RE: Supporting statement for the proposed NMA in relation to 24/0066

Planning Application Reference: 24/0066

Planning Application Proposal: REFURBISHMENT OF UNITS 3 & 4 (CLASS A1) COMPRISING EXTERNAL ALTERATIONS INCLUDING NEW SHOPFRONT AND LOBBY TO CREATE A SINGLE RETAIL UNIT, CREATION OF SERVICING PLATFORM TO REAR, CAR PARKING RECONFIGURATION, CYCLE STANDS AND TROLLEY BAYS, PLANT ENCLOSURE AND ASSOCIATED WORKS

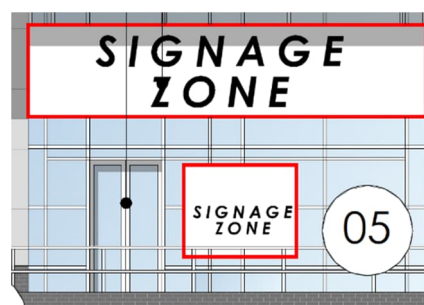
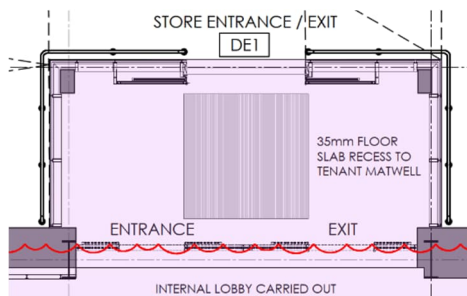
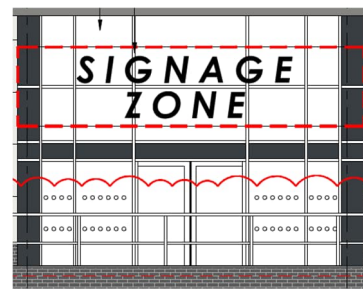
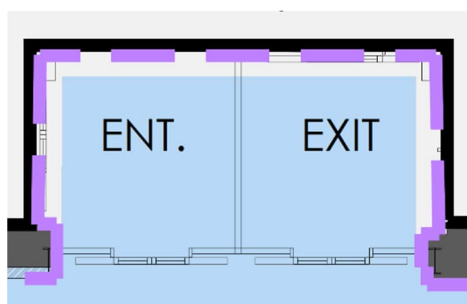
On the original planning approved drawings, the Entrance and Exit doors are shown as two separate entities; the exit doors are shown to the primary elevation of the curtain wall offset from the centre, with the entry doors on the return corner.

Given the location of an existing steel column in relation to the bi-parting entrance doors, the opening of the door is limited and as approved compliance, would not give the clear opening width to achieve Building Regulations.

The NMA proposals now show the Entrance / Exit from the store solely from one door as the entrance door on the return elevation has been removed. The new position of the door allows for a double bi-parting door which is not limited by the existing steel columns and so achieves the required clear opening width.

Centralising the position of the door also means there are now fewer aluminium aspects to the framework as we have removed mullions / transoms now allowing for full height uninterrupted glazing.
